CHAPTER 343, HRS
Environmental Assessment/Determination
Negative Declaration

**FINAL
ENVIRONMENTAL ASSESSMENT FOR
SHORE PROTECTION AT
870 MOKULUA DRIVE, LANIKAI, OAHU
TMK 4-3-08:50**

The following comments from the Lanikai Association are in regard to the Huitt Lanikai Revetment Replacement, TMK 4-3-8-50, applicant, John D. Huitt Jr.

Subject: Response to Comments on Huitt Revetment Construction, 870 Mokulua Drive, Lanikai, TMK 4-3-8:50

1 PROPOSED REVETMENT PLAN
 C-2 SCALE: 1" = 10'

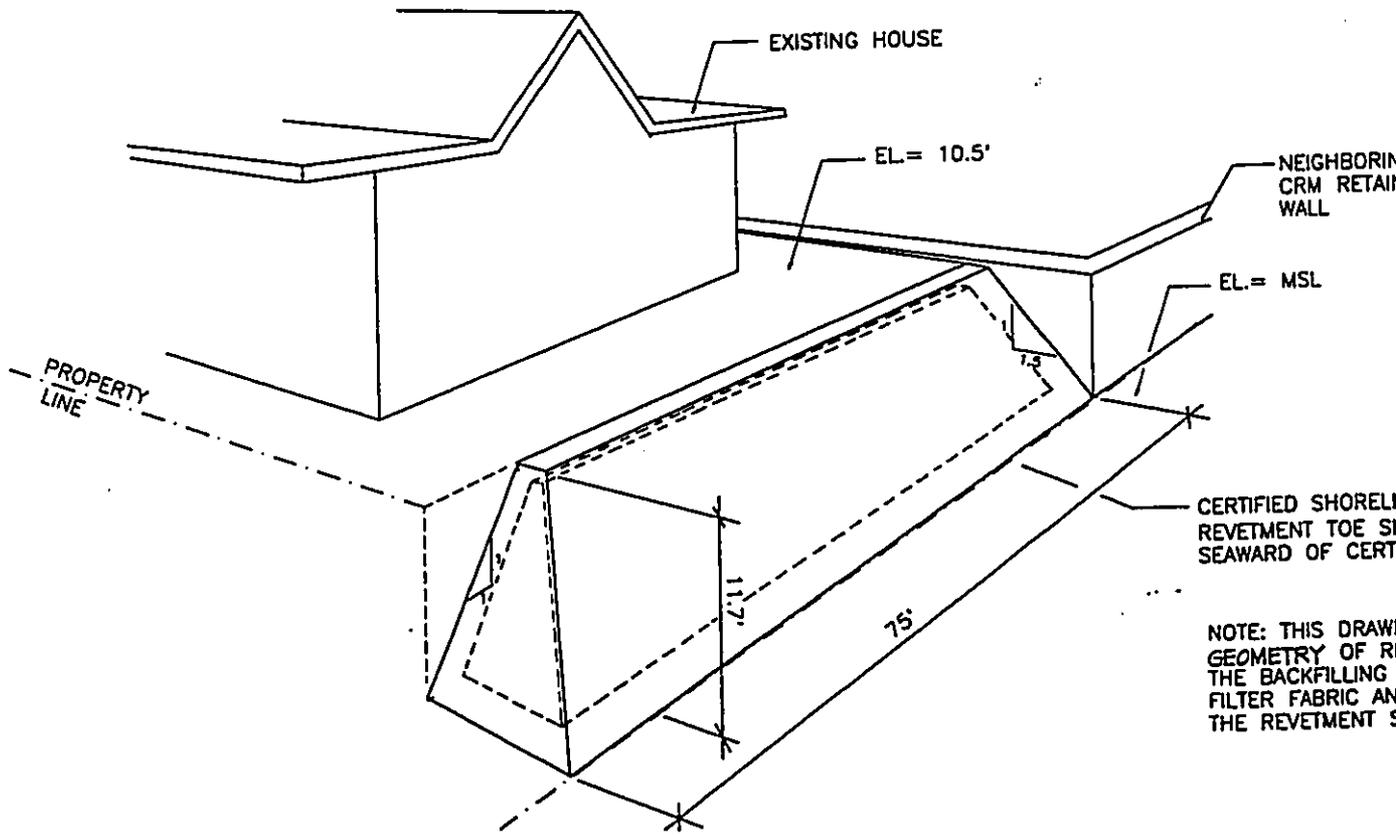
How can we be sure that the toe of the revetment will extend no farther into the ocean than the existing illegal revetment?

Based on our review of the Environmental Assessment, the toe of the revetment appears to be landward of the certified shoreline and above the mean high water (MHW) line. Provided that none of the construction work, including temporary structures, fill or equipment activity, extends below the MHW line, a Department of the Army permit is not required.

The toe of the revetment will extend no further seaward than the certified shoreline. At the certified shoreline, the toe will be covered with sand under most wave conditions. Construction will be inspected by a professional engineer who will have to certify that the revetment is constructed according to the specification. A contractor who does not follow the specification may be required to redo the revetment or may not be paid by the owner.

Thank you for your comments on the subject revetment construction. As you stated, the design specifications for this revetment require the contractor to place the toe landward of the certified shoreline. However, although the construction method has not yet been determined, it may be necessary to operate equipment such as a small backhoe on the beach. This disturbance will be temporary, and the specifications require the contractor to return the beach to its original condition after completion of construction. The revetment construction will be monitored by a professional engineer to ensure that specifications are met. The property owner and construction contractor will be informed of the conditions requiring a Department of the Army Permit.

1 CROSS SECTION
 C-3 SCALE: 1" = 4'

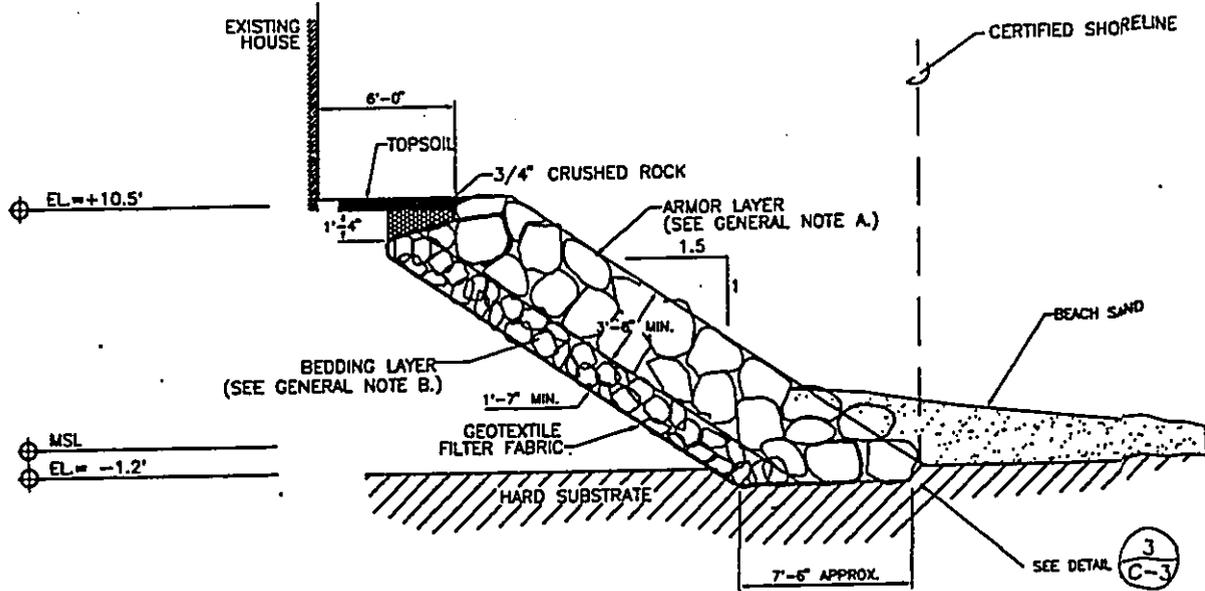
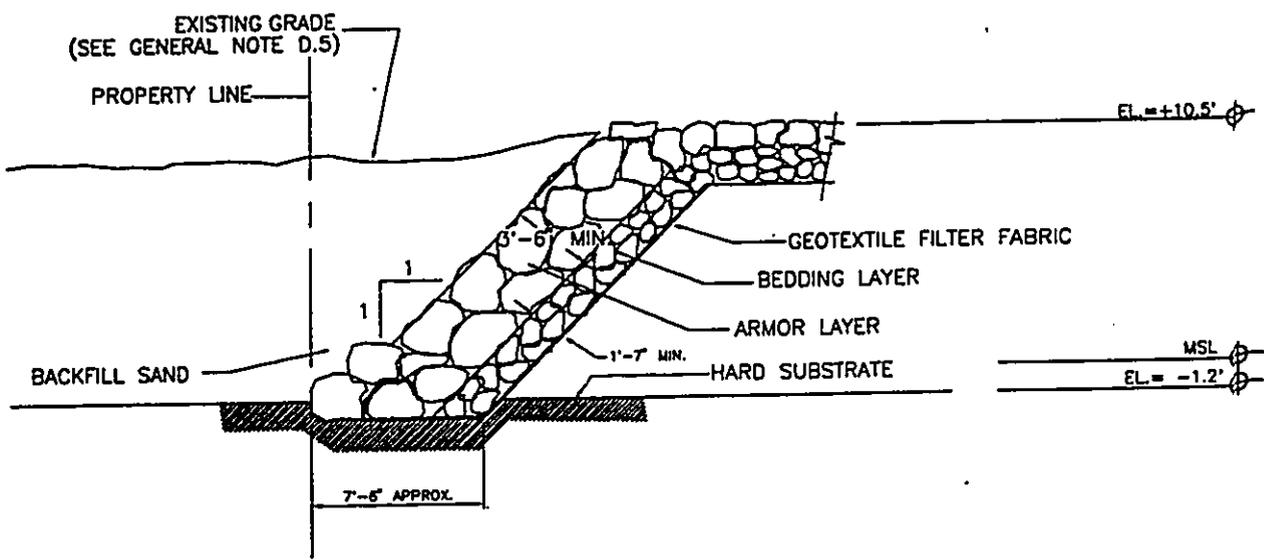
How was the 1-1/1-1.5 slope for the revetment determined? Is this angle sufficient to discourage erosion? The contractor doing the renovation to the existing house pointed out to us the perilously close location of the house to the water's edge. He said a longer slope would bring the top of the revetment to the edge of the house foundations. Should they not consider

The slope of the front face of the revetment is 1 vertical to 1.5 horizontal. This is the maximum slope recommended by the U.S. Army Corps of Engineers in their coastal design manuals. Slopes of this steepness or shallower generally have minimum effect on beach sediment transport and may encourage beach growth in some cases. A revetment shallower than 1:1.5 will require excavation very close to the house foundation and could result in soil slumping and resulting damage to the house. The house has already started to crack due to soil movement probably caused by erosion

at the existing revetment. In addition, the owner would not be able to use the seaward door of the house because there would be no place to walk. Presently there is approximately 8-10 feet of level space between the wall of the house and the top of the revetment. Moving the house back is not a viable solution because of the high cost and potential for damage.
